Taco Time

Stormwater Site Plan

Drainage Report

DATE: July 11, 2023

Figure I-3.1: Flow Chart for Determining Requirements for New Development

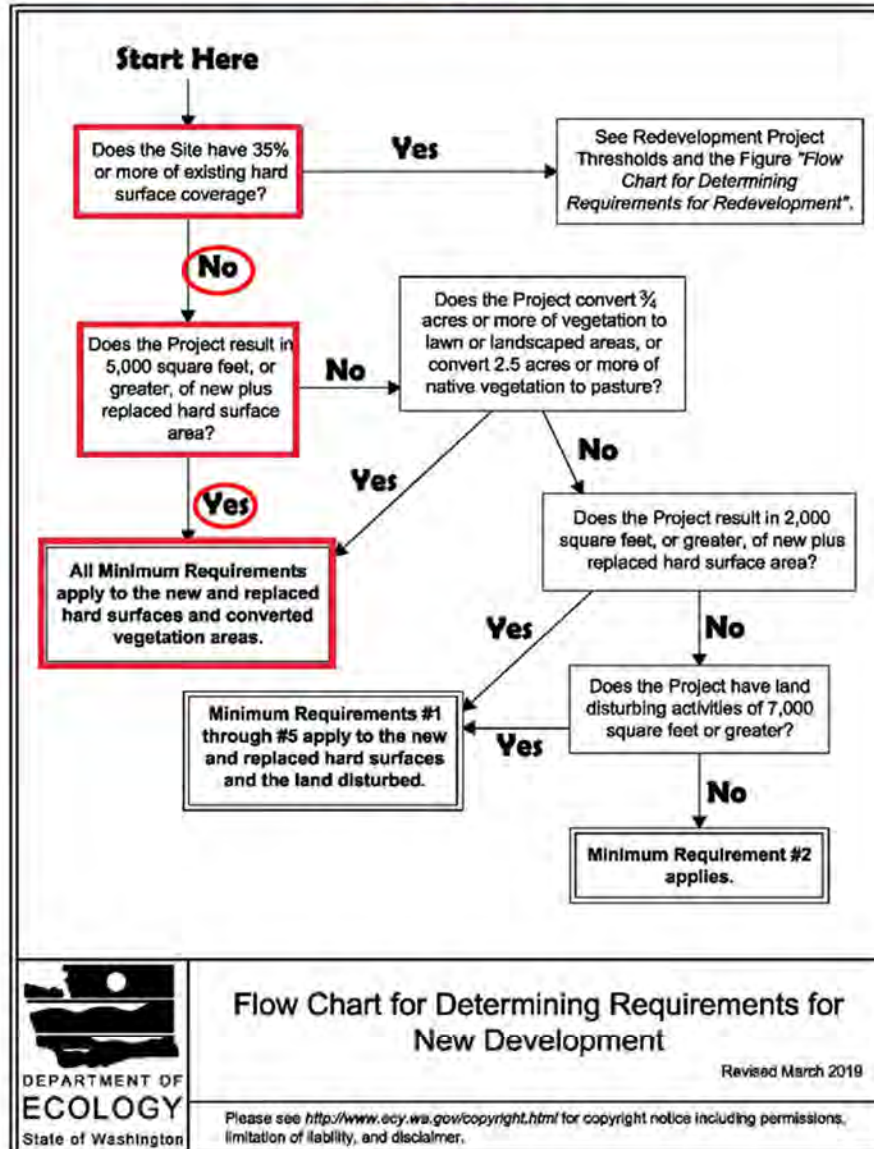
Provide an area table in section 1 to use in determining minimum requirements. The City encourages using the table provided during Preliminary Site Plan to ensure all required areas are tabulated. Email Lance Hollingsworth if you have trouble finding this table again. [Storm Report, Pg 3]

It appears there may be more than one TDA onsite. Define the different TDAs with a numeric naming convention (TDA 1, TDA 2) and show in a TDA map. Use the TDAs when considering minimum requirements 6,7, and 8 per the Ecology Manual. [Storm Report, Pg 3]

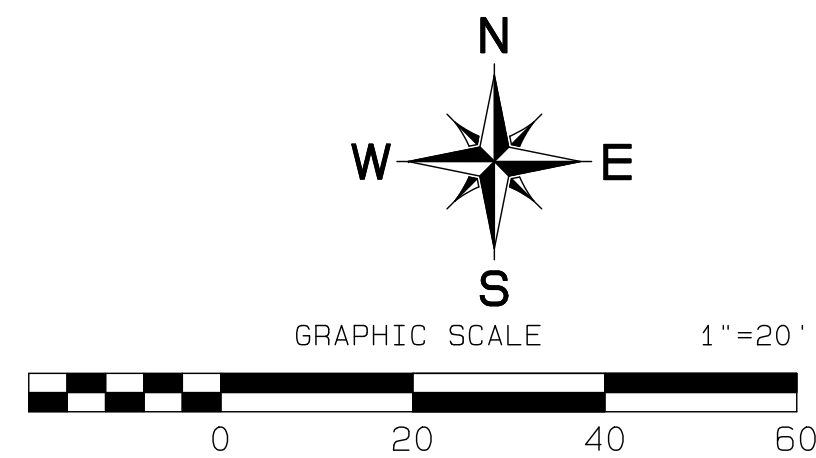
New plus replaced hard surface area needs to be recorded for all basins. and added in table. Use table from preliminary site plan. [Storm Report, Pg 137]
